To: All Plan Holders of Record

Re: *Addendum No. 1*
Jefferson Booster Station Replacement
Ashtabula County Board of Commissioners, OH

Date: July 17, 2026

ASHTABULA COUNTY	JEFFERSON, OHIO
JEFFERSON BOOSTER STATION REPLACEMENT	
ASHTABULA COUNTY	
BOOSTER STATION- 10 SERIES	
BOOSTER STATION DETAILS -1

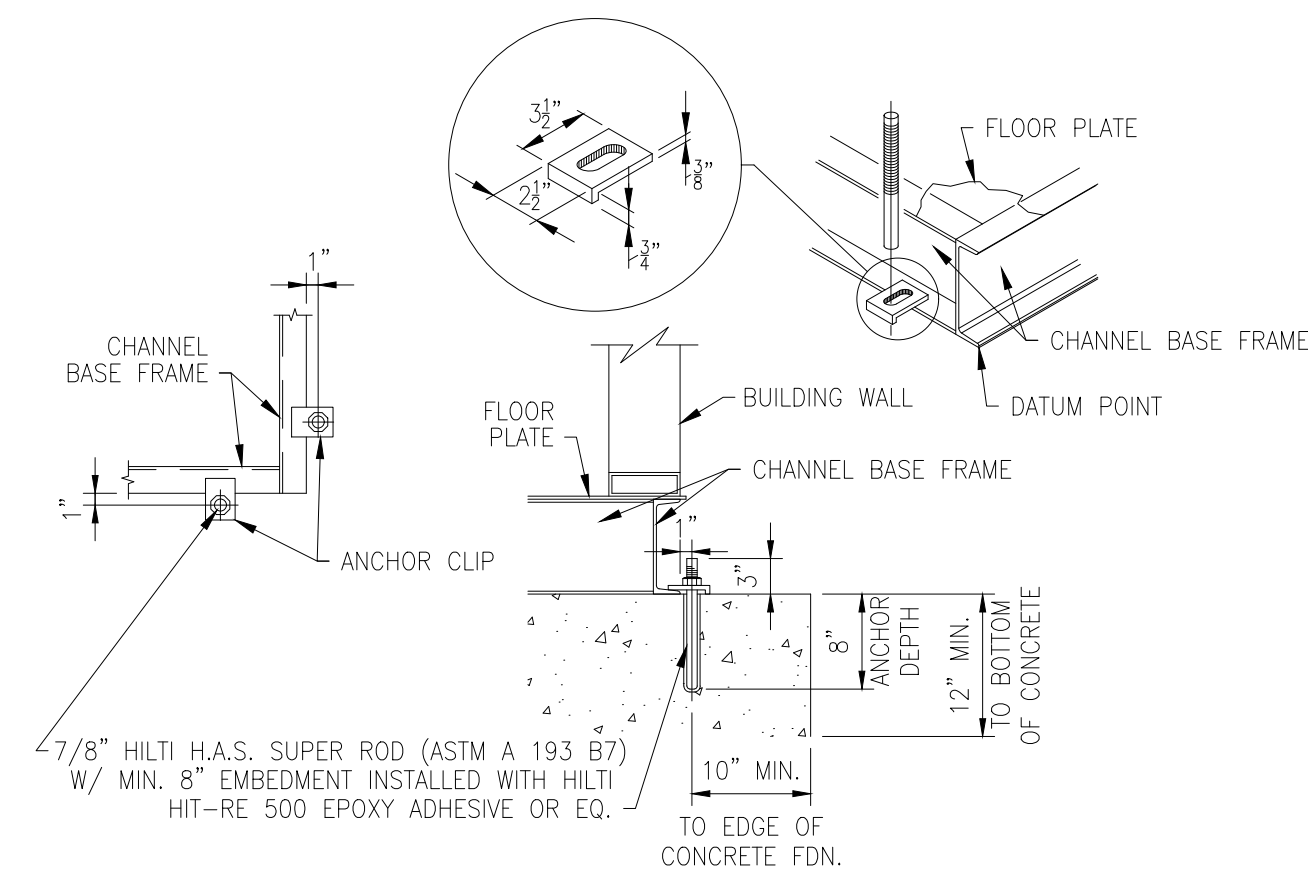
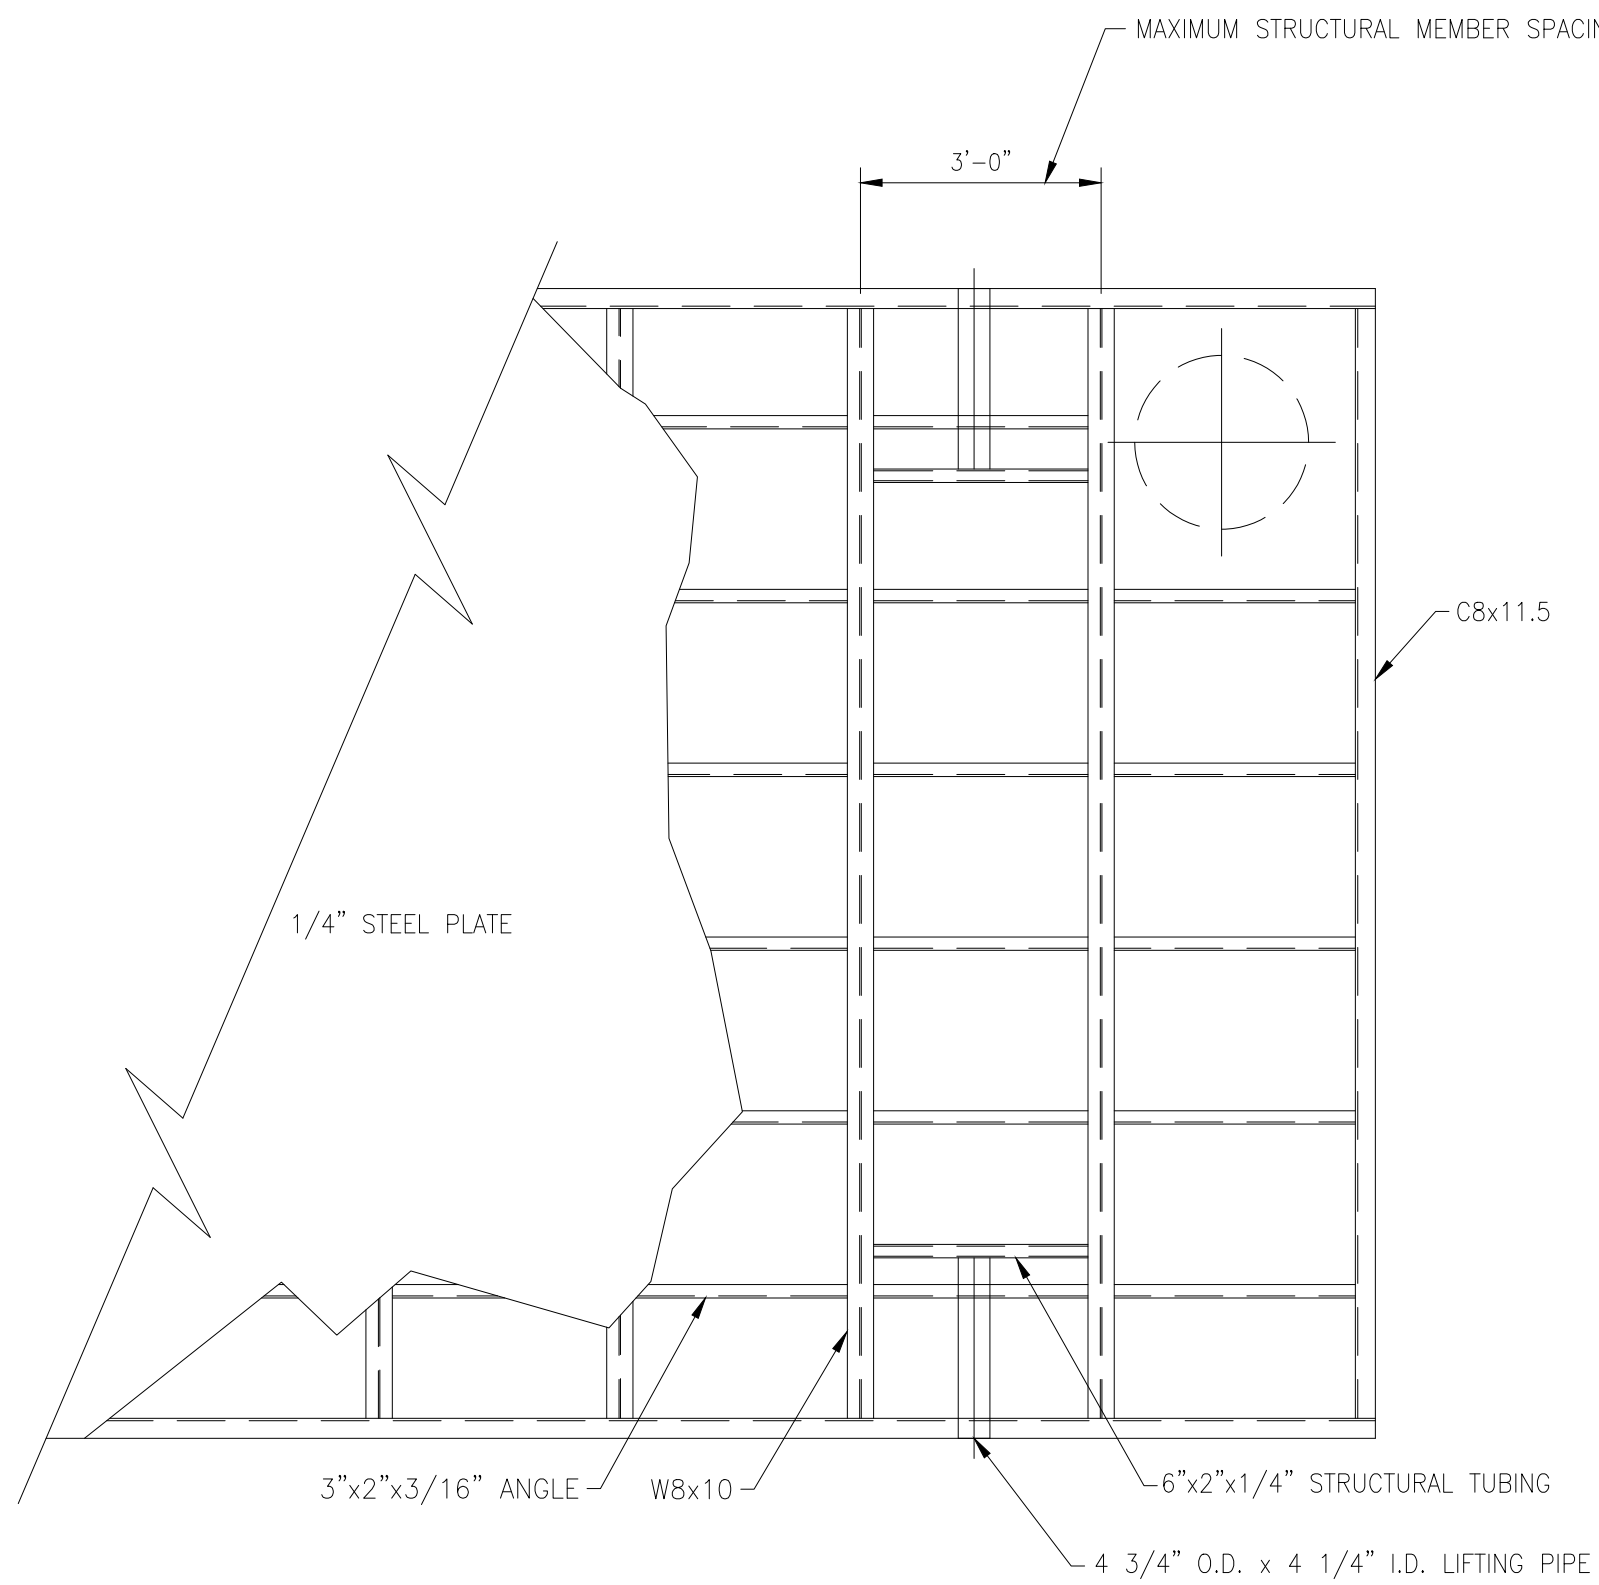
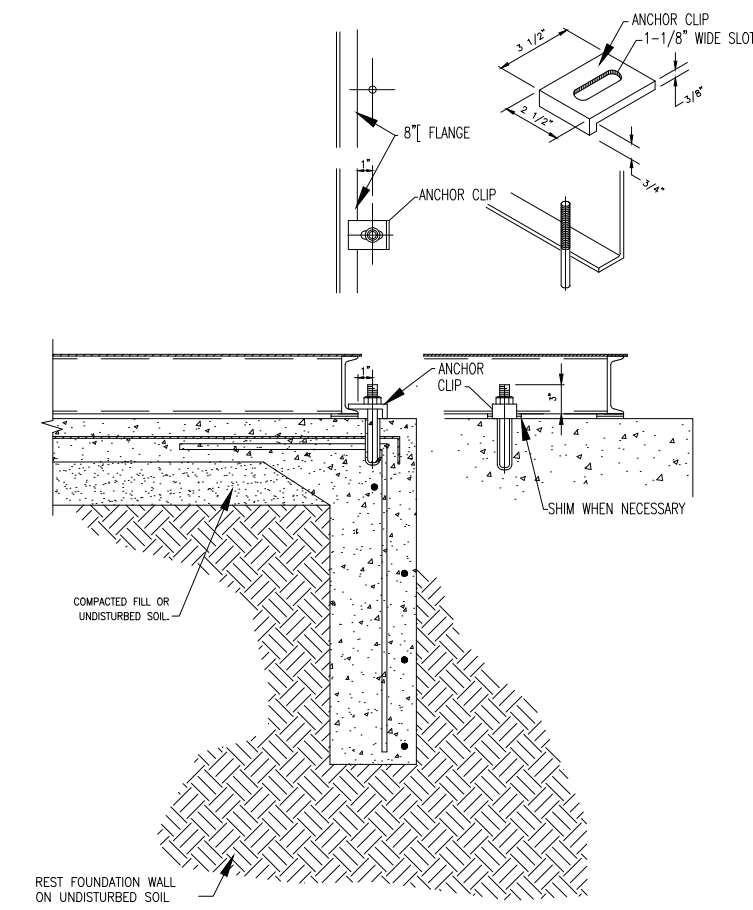
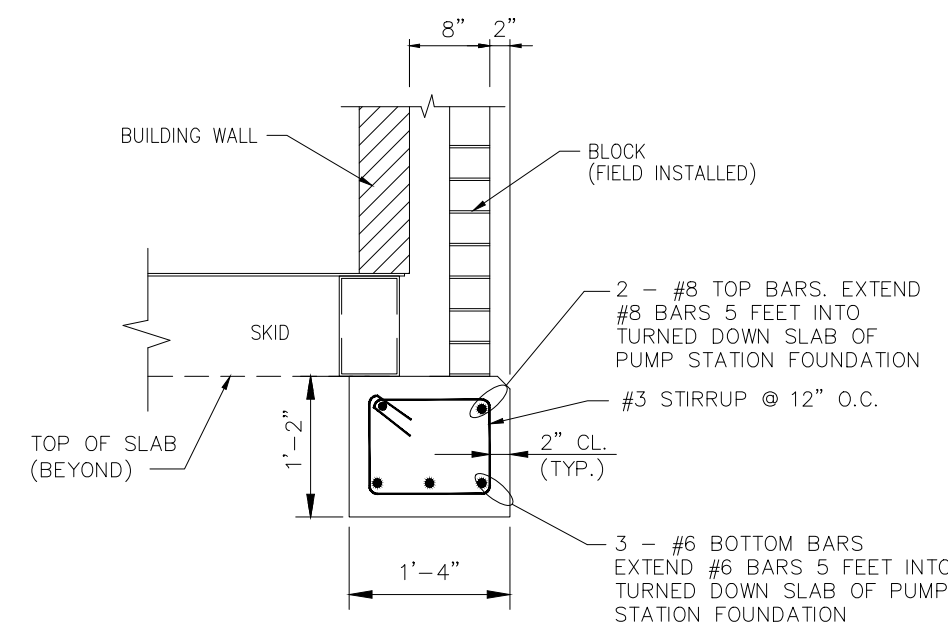
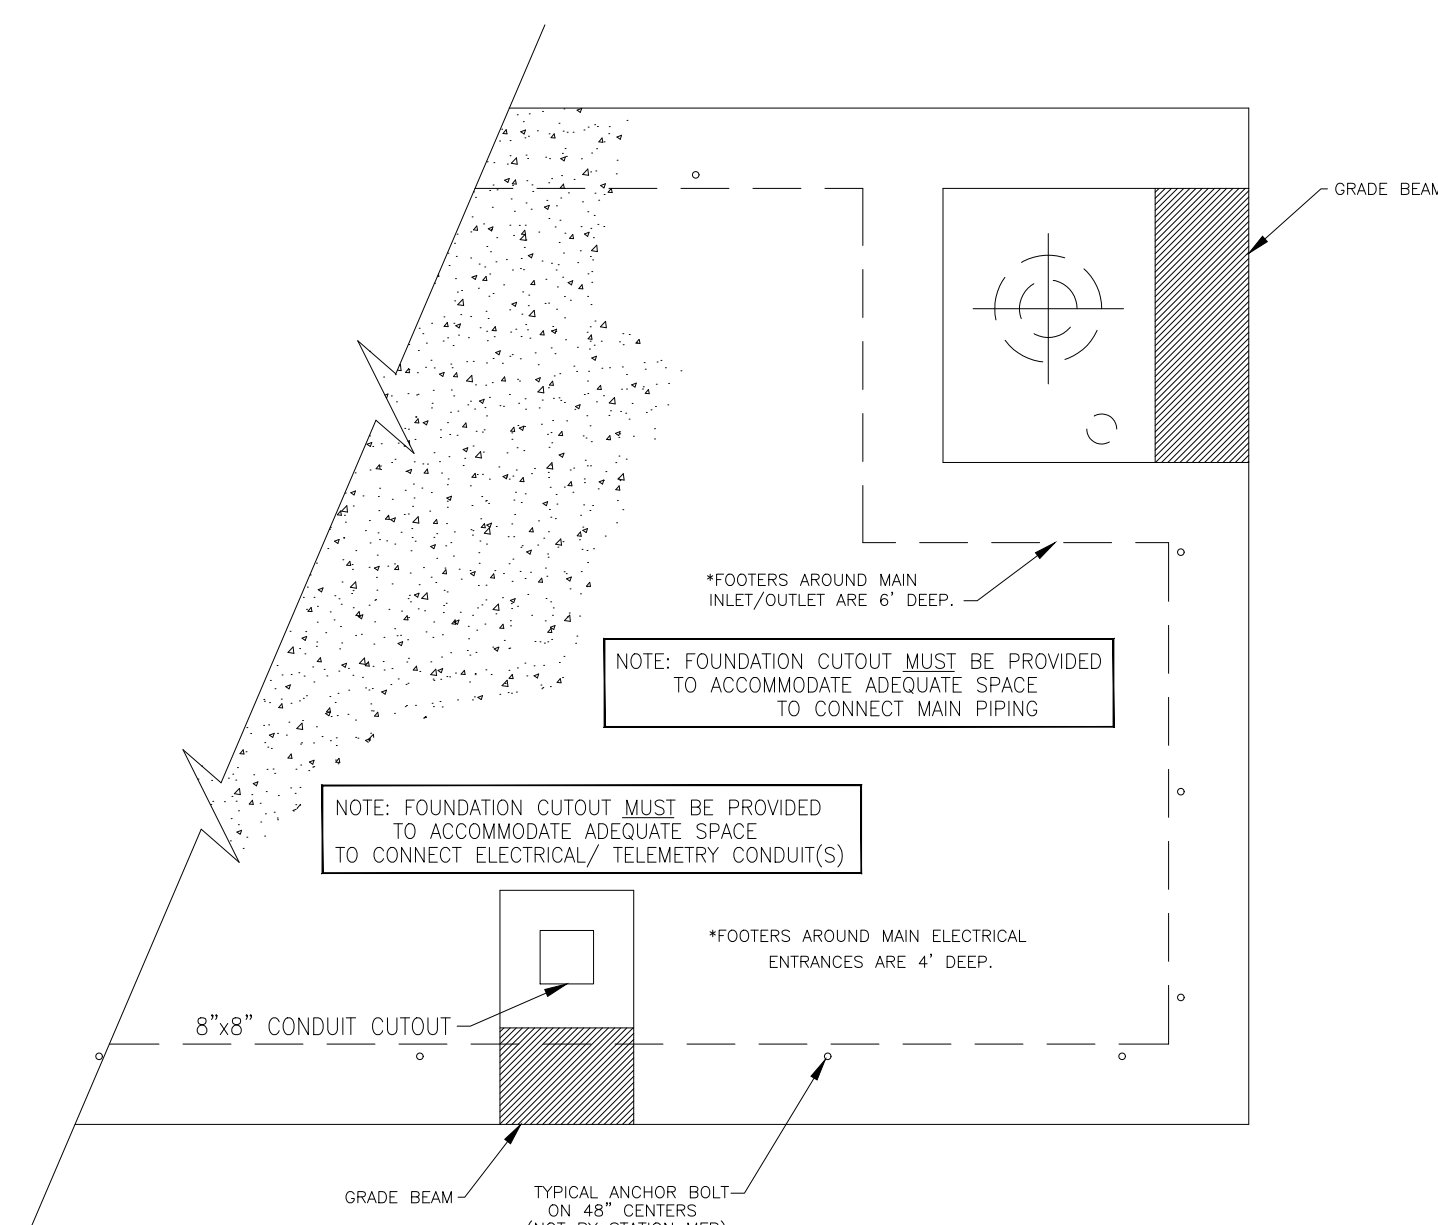
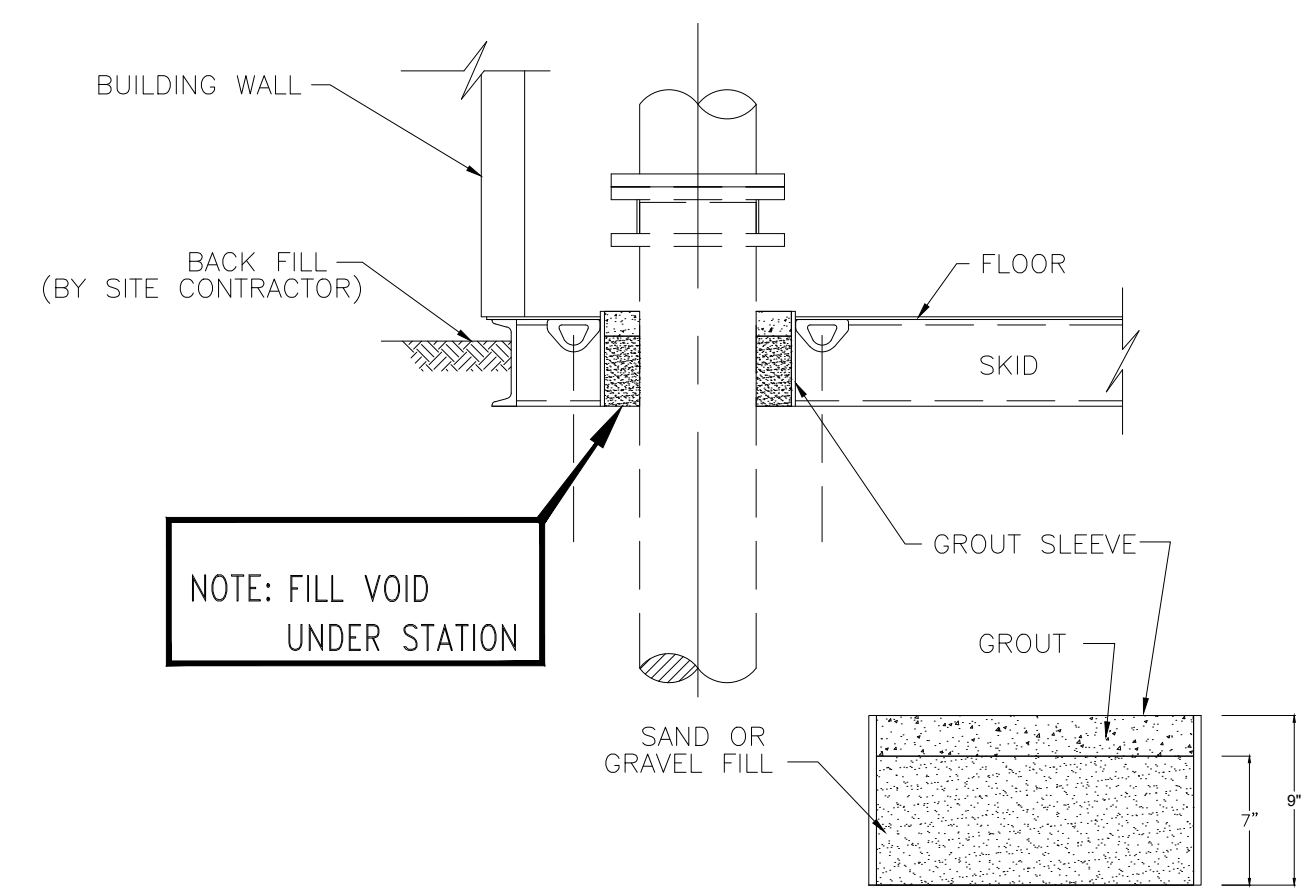
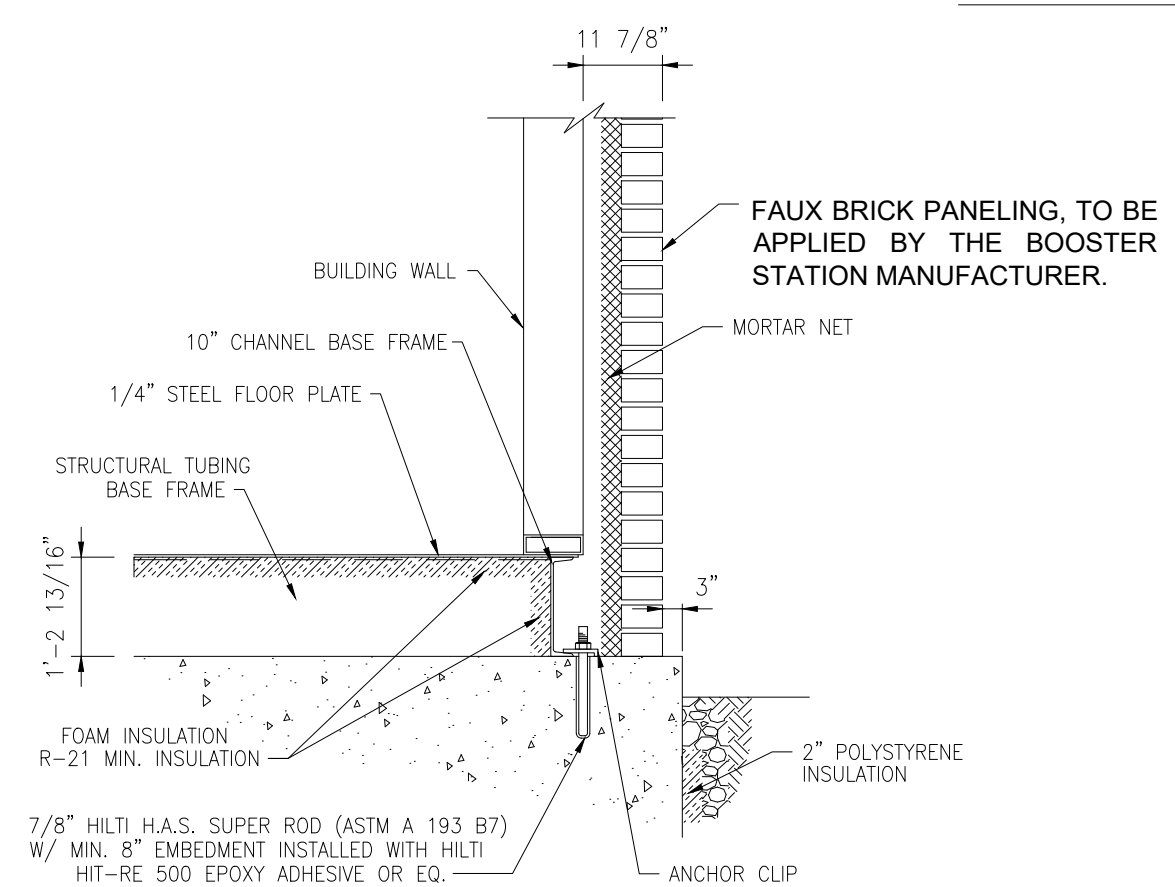
Q7. Can you provide additional details or specifications describing what is required for the exterior of the booster station building.

Replace BOOSTER STATION DETAILS-1, sheet 12/17 with the enclosed BOOSTER STATION DETAILS-1, sheet 12/17.

A7. Faux brick paneling will be applied by the station manufacturer prior to shipment, see modified sheet 12/17.
